REPORT FOR ACTION

Appeal Concerning One First Party Roof Sign at 164 Evans Avenue

Date: March 14, 2019

**Re: Signage Master Plan Application
164 Evans Avenue, Toronto Ontario**

VIEW LOOKING SOUTH FROM ON-RAMP TO
GARDINER EXPRESSWAY

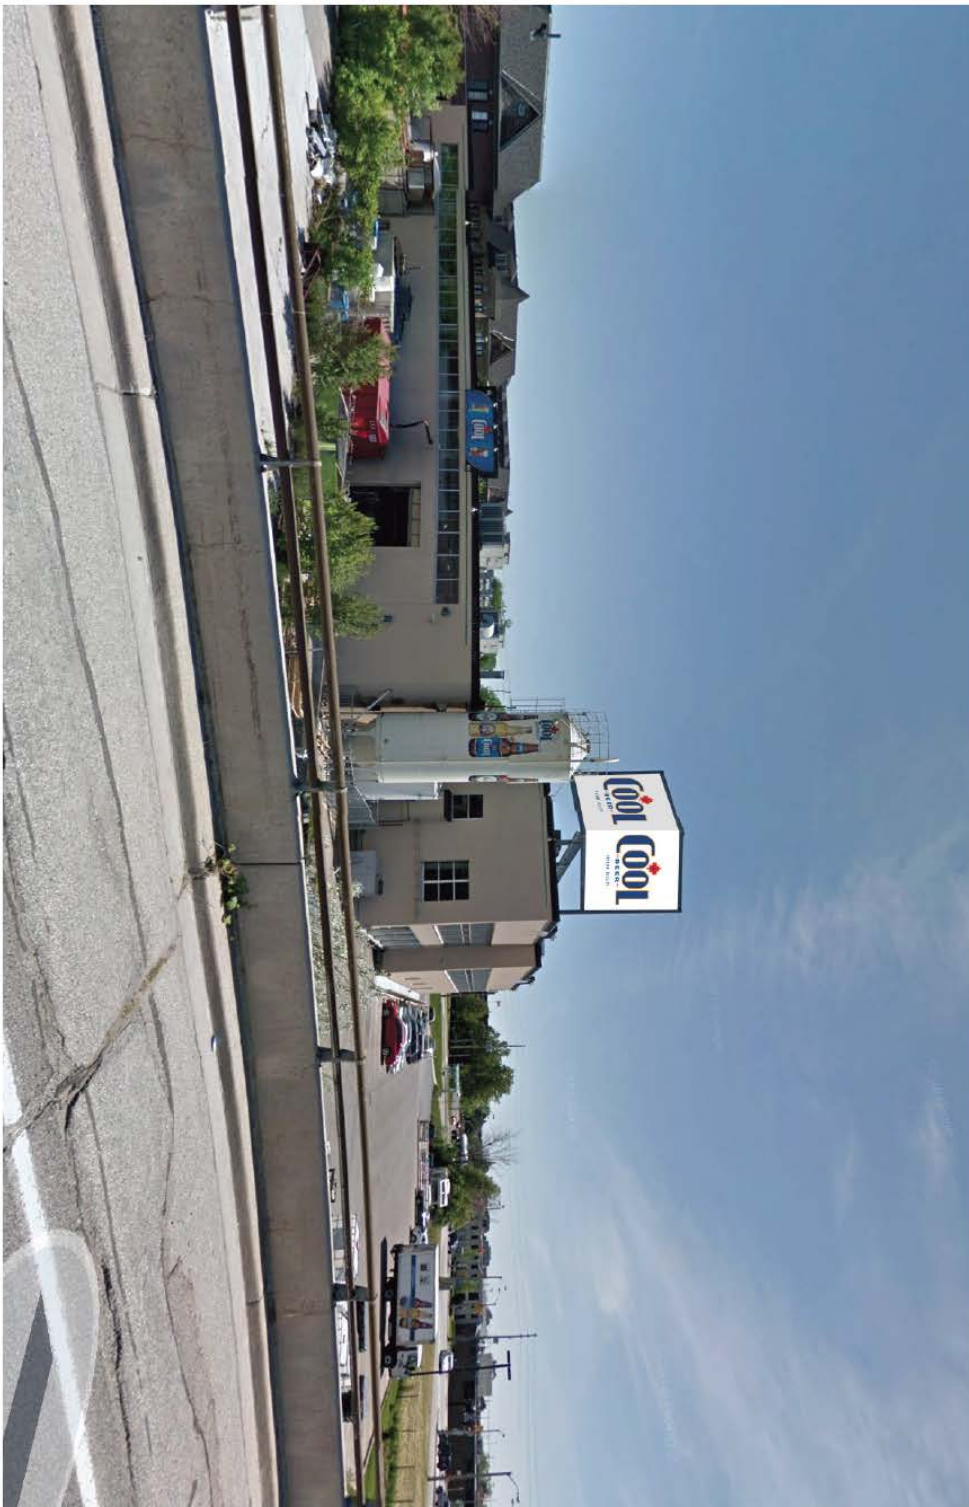
Figure 3 below shows a screen capture from Google Streetview in October 2018, with the existing sign structure located above the newer addition to the brewery. This image clearly demonstrates the difficulty of integrating a roof sign into the overall design and architecture of a building. Staff do not agree with the applicant's suggestion that the Proposed Sign would "blend well" with the exterior tank structures.

Attachment A - Other Roof Signs

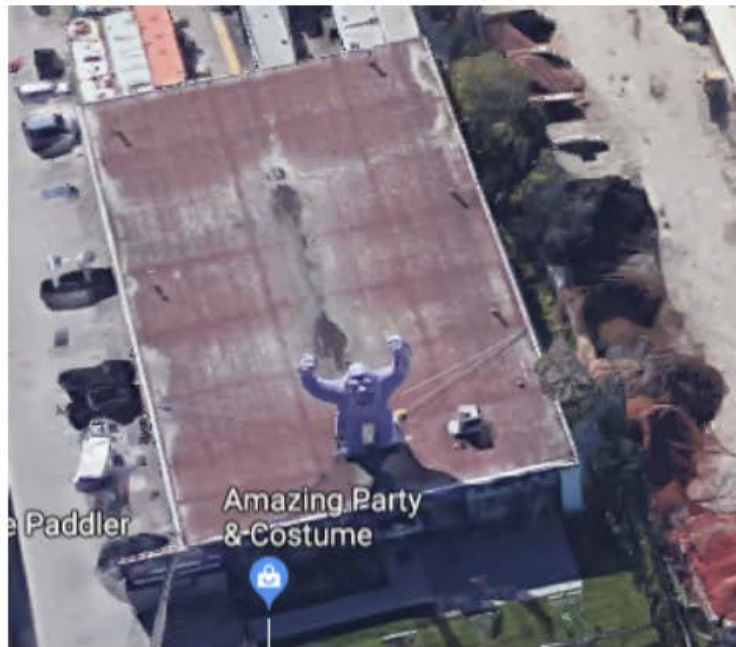
(a) According to City records, the existing roof sign at 855 Oxford Street does not appear to have been lawfully erected. Are there examples of other comparable lawfully erected first party roof signs in the surrounding area?

There does not appear to be any other first party roof signs approved in the area under the current sign by-law.

I also note that there is a roof sign for Canadream located at 24 The East Mall, at the interchange of 427 and The Gardiner. I cannot speak to the legality of this site, other than to point it out as part of the context along The Gardiner at an interchange.

Both the Cineplex and Canadream roof signs are located at the edge of the buildings facing The Gardiner and are of a similar size to that proposed at 164 Evans, which is also at an interchange with The Gardiner and faces the Gardiner at the edge of the building. In each case the elevated roof sign provides for visibility to advertise the business as the grade increases up the ramps to the Gardiner.

Photos of the Cineplex and Canadream signs are provided in Attachment A.
